SYSTEM **aLIGO**

PART NAME **LIGO 1 OSEM MOUNT**  
**(FOR PENRE MASS)** v3

DRG. NO. **D060349**

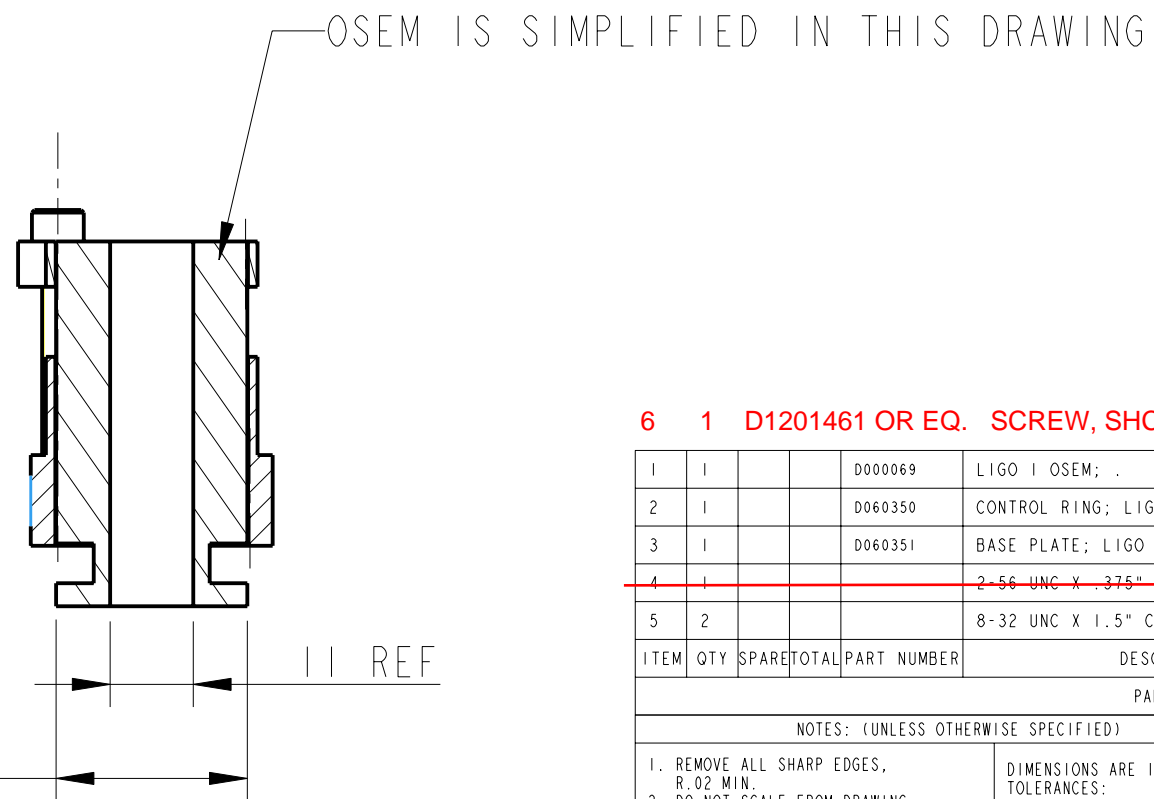
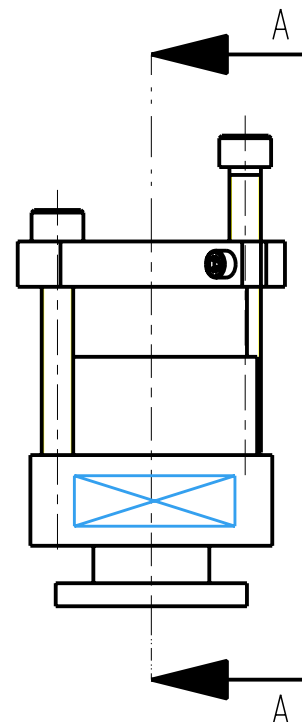
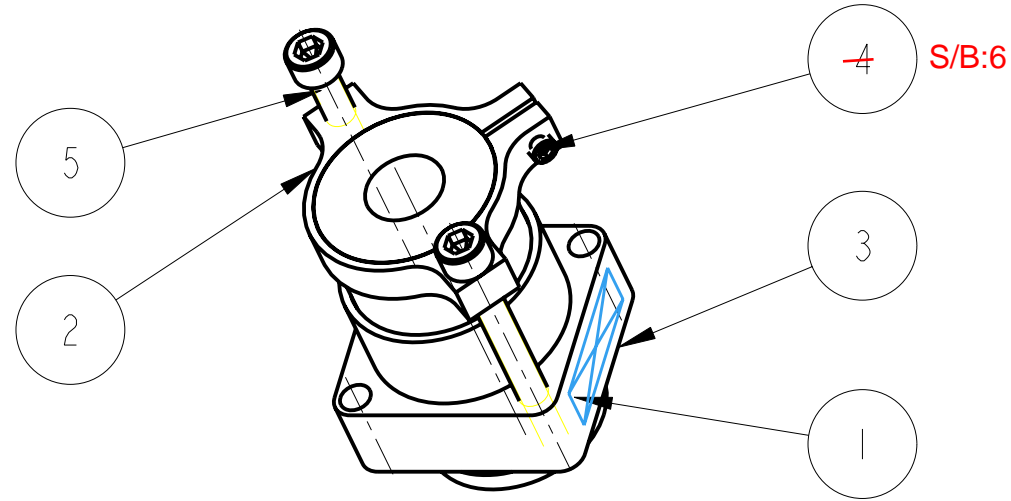
v3 12 NOV 2012 E1201008-x0

6 1 D1201461 OR EQ. SCREW, SHC, #2-56 X .38 LG. PEEK

| ITEM | QTY | SPARE | TOTAL | PART NUMBER | DESCRIPTION                             | MATERIALS                |
|------|-----|-------|-------|-------------|---|--------------------------|
| 4    | 1   |       |       |             | <del>2-56 UNC X .375" CAP HEAD; .</del> | <del>ST STEEL: 316</del> |
